ADDENDUM

ADDENDUM NO: 03

PROJECT: Center Grove HS Renovations – Package 2

DATE: September 4, 2026

4 CONSTRUCTION LAB 127 - EXISTING RELAY PANEL AND KEYED SWITCH

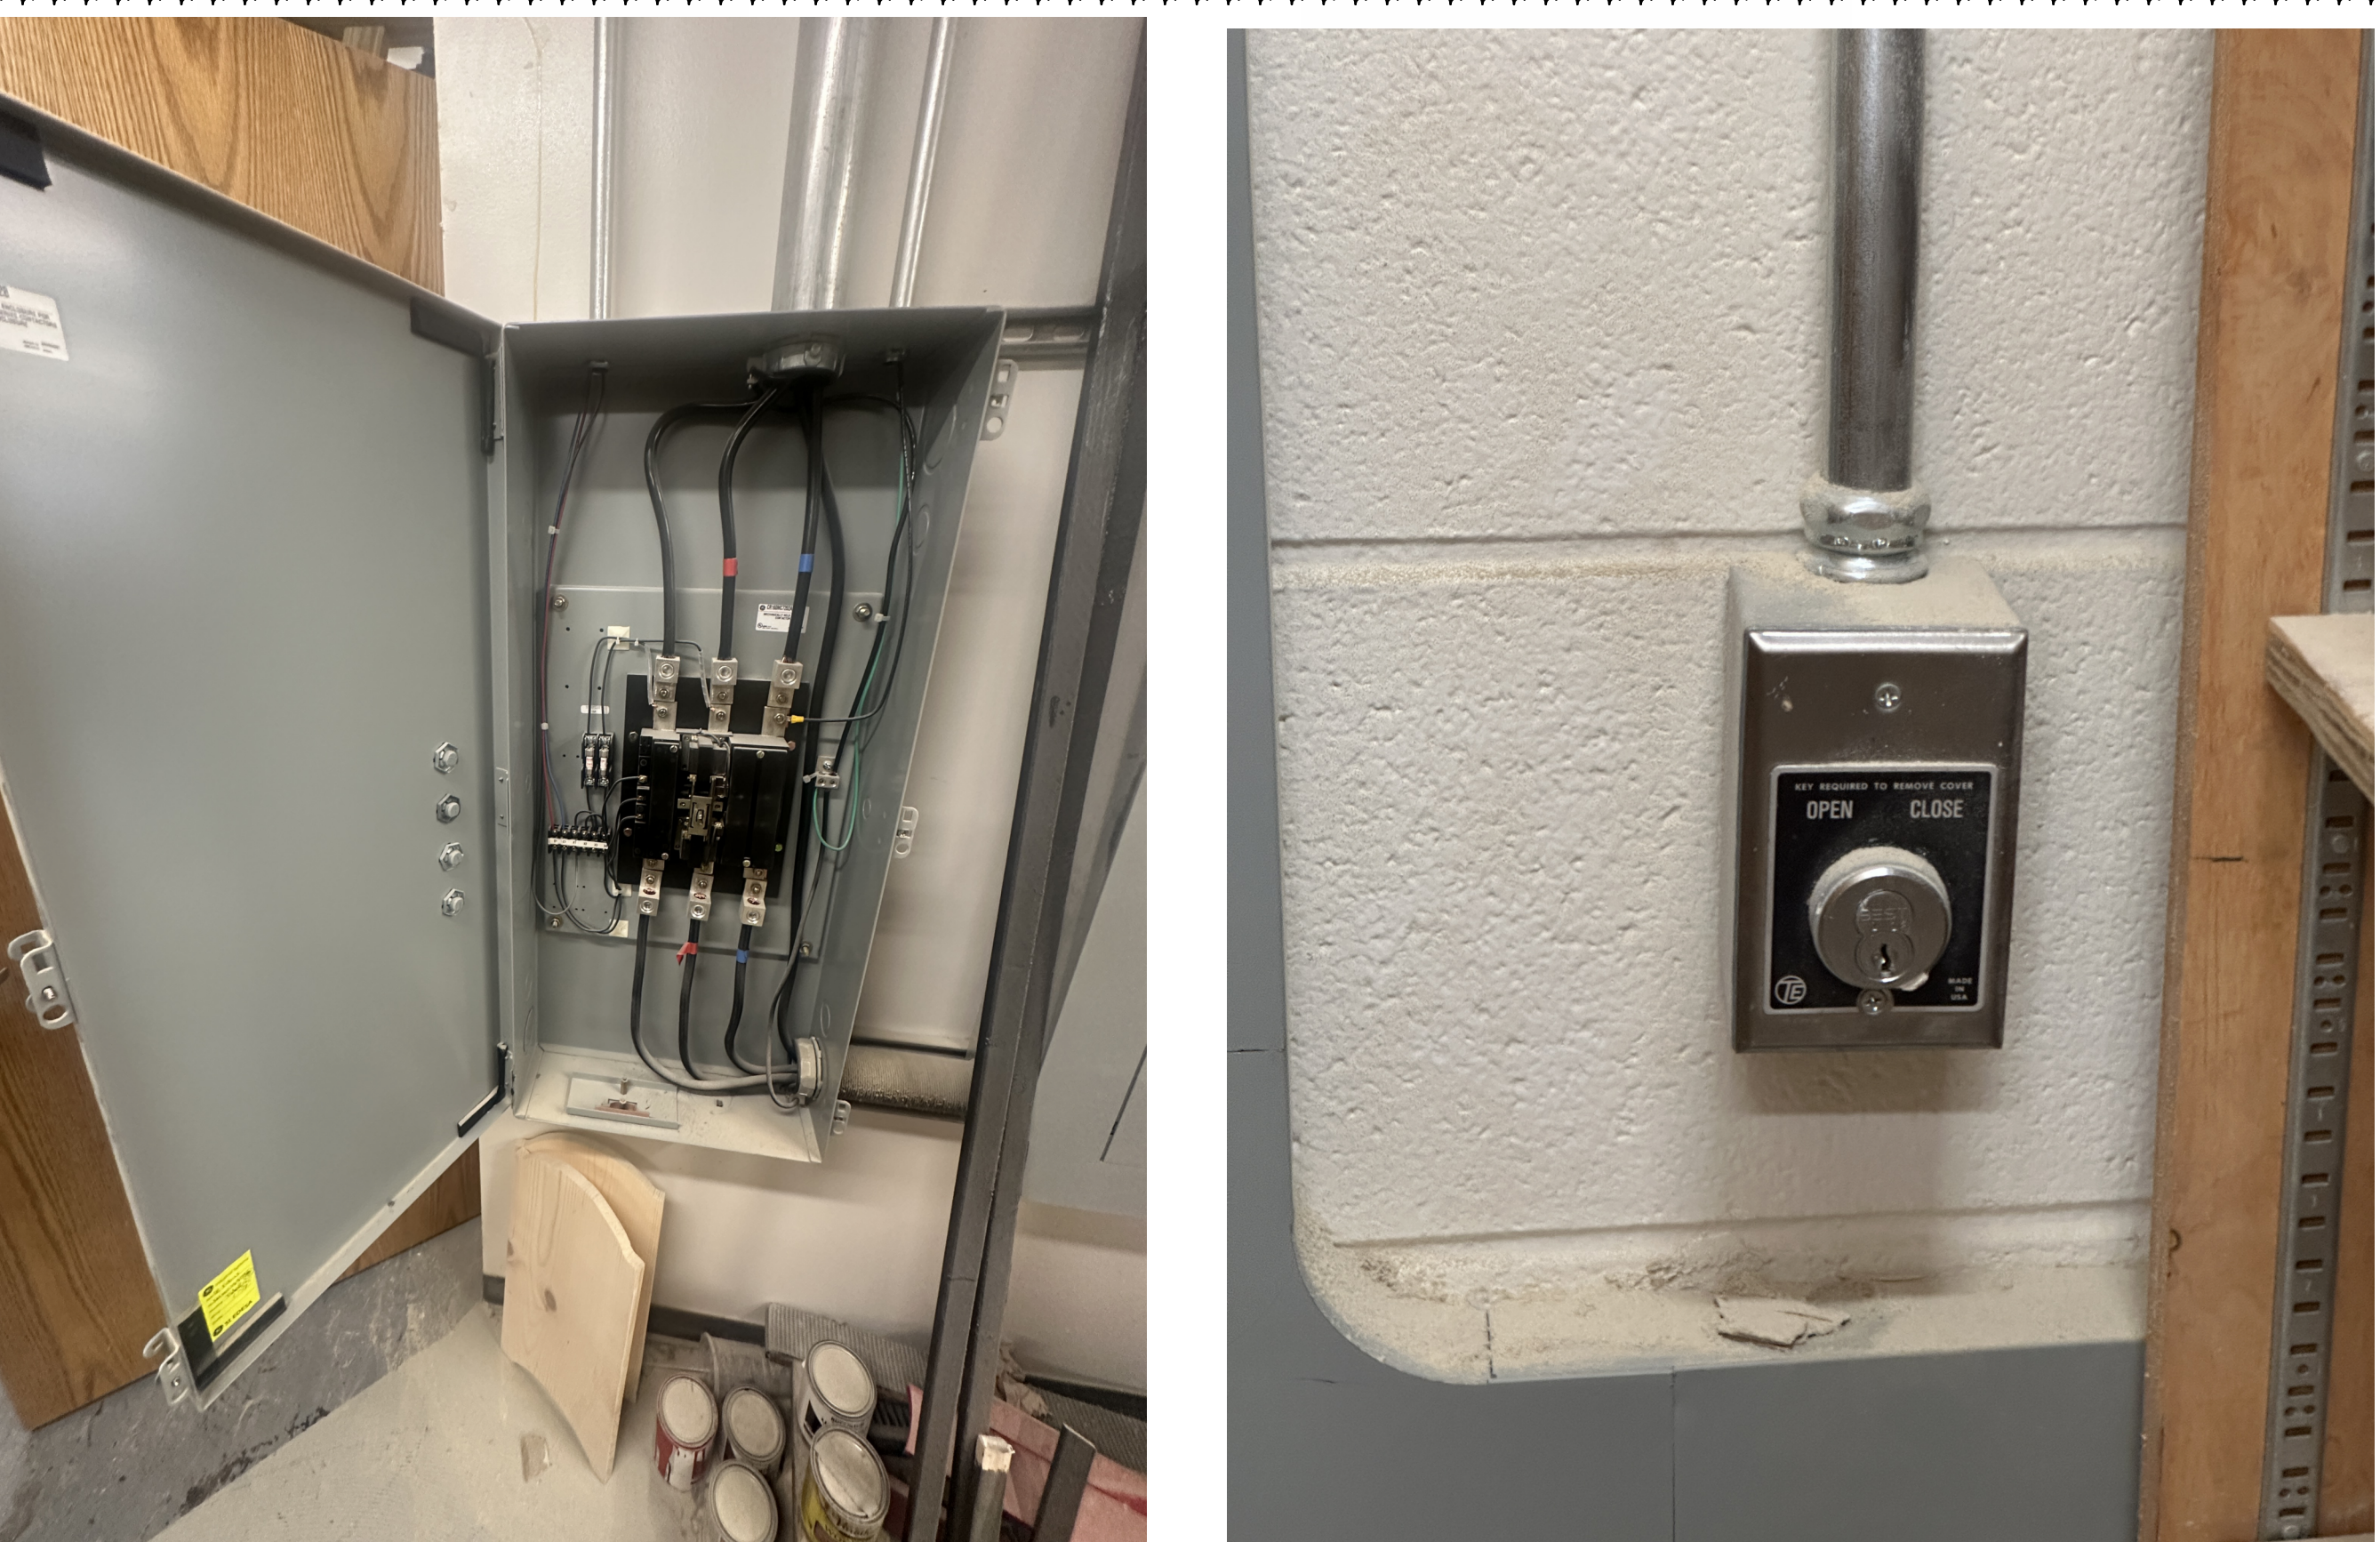
- A. Removed two motorized switches previously serving (2) WF-1.
- B. Added one (1) non fused disconnect for new WF-1.
- C. Added one (1) 480/277V MH panel.
- D. Added tagged note ENC71.
- E. Replaced 75KVA transformer with 45KVA transformer, Updated tagged note ENC58.
- F. Updated wire size between T-ML (transformer) and ML (panel). Tagged note ENC59 updated (wire size from 3-4/0 to 3-1/0 and ground size from #2 to #6).
- G. Added CONSTRUCTION LAB 127 – EXISTING RELAY PANEL AND KEYED SWITCH view.
